# Modification Recommended Service Note

## N8925A - Autoranging System DC Power Supply, 80V, 340A, 10000W, 208 VAC

Serial Numbers: DE14290000 - DE15369999 without manufacturing ID Version "B"

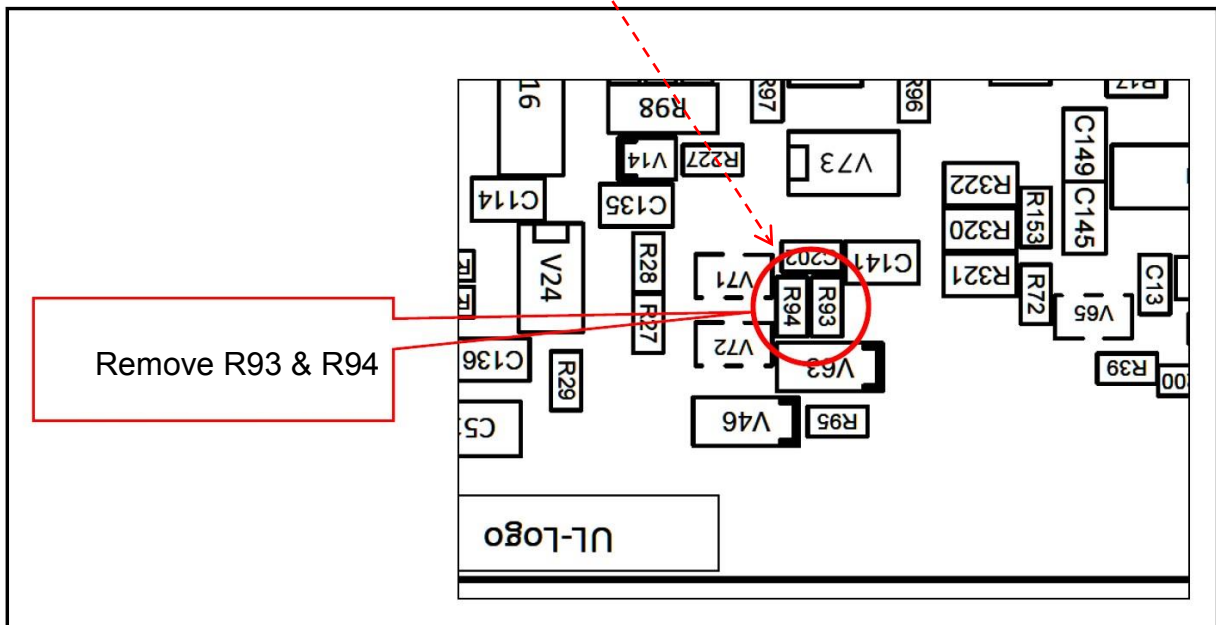
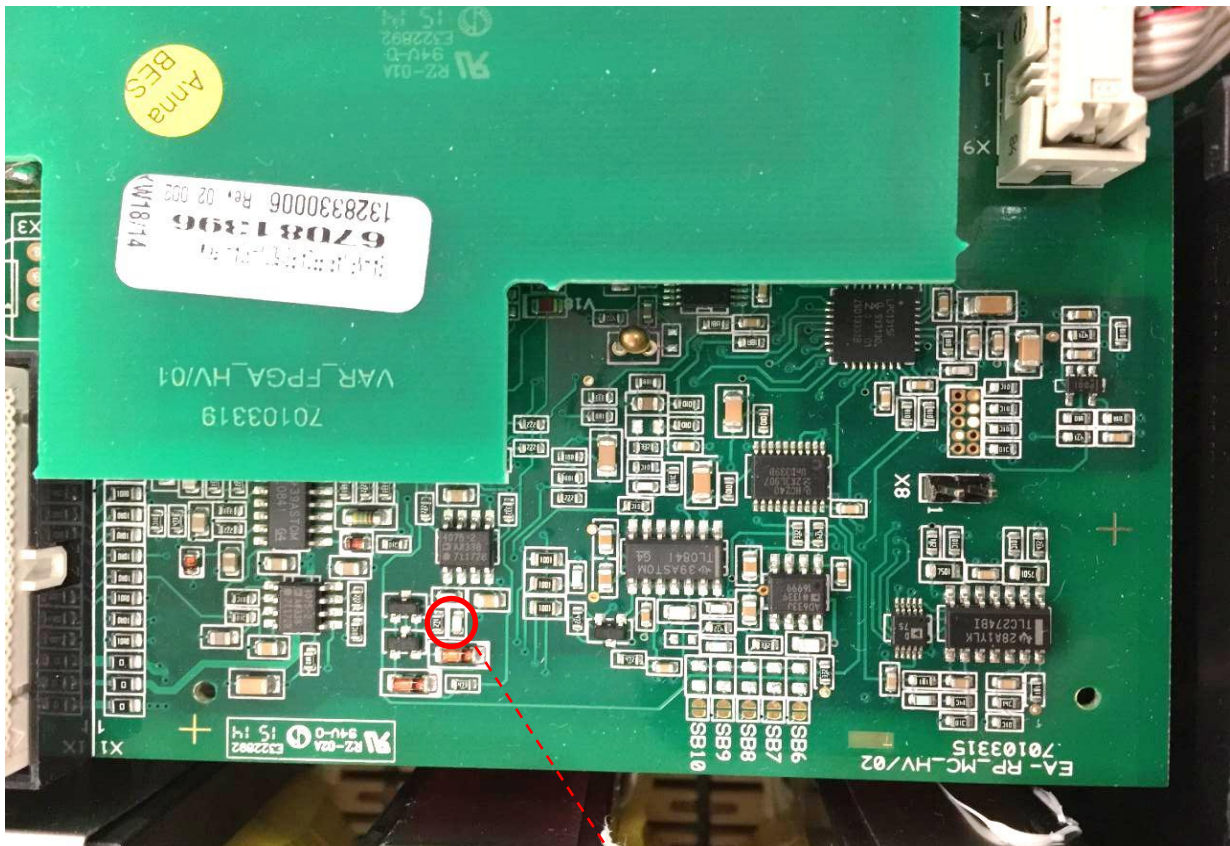
- 1) Remove acMains cable from power source.
- 2) Wait 5 minutes
- 3) Remove top cover from instrument.
- 4) In the 5kW units (viewed from the front of the unit), a small SMT assembly located at the right-rear of instrument will be readily visible (see below):

In the 10kW & 15kW units; although found in the same location, a black plastic cover will have to be removed to gain visibility and access to the SMT assembly. Plastic cover snaps-on and can be removed with a small screwdriver.

5) SMT resistors R93/94 are located in red circle shown below:

Removal of two (2) surface mount resistors, R93 and R94, will correct this problem:

Suffix “B” added

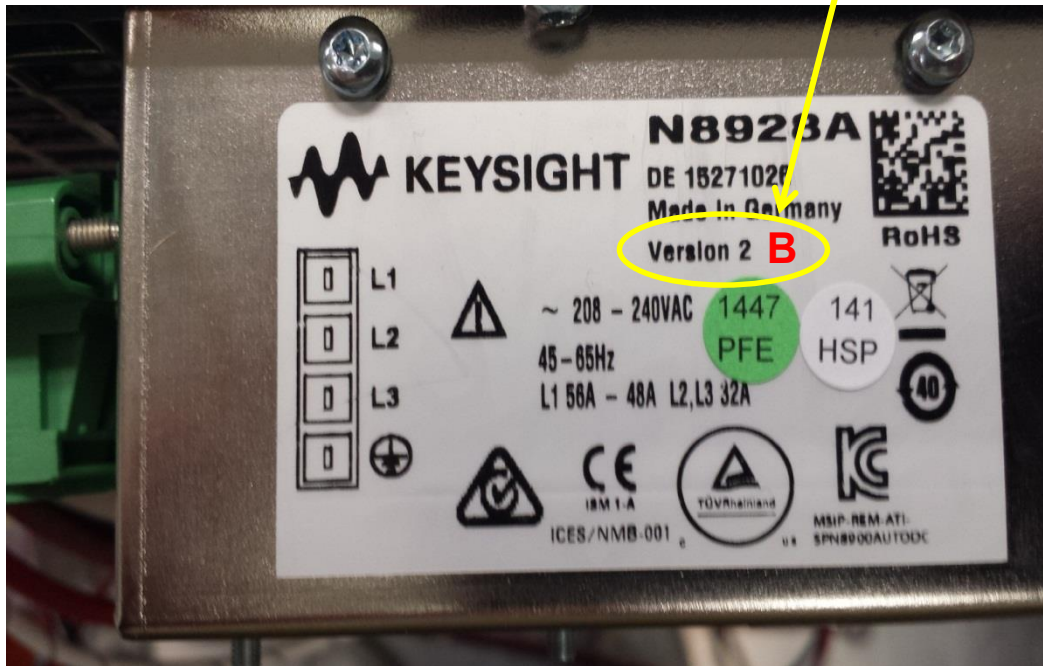
7) On the acMains label, on the rear of the instrument; use an indelible marker, to add the suffix letter “B” after the Version ID. This will assist in the tracking of modified instruments.
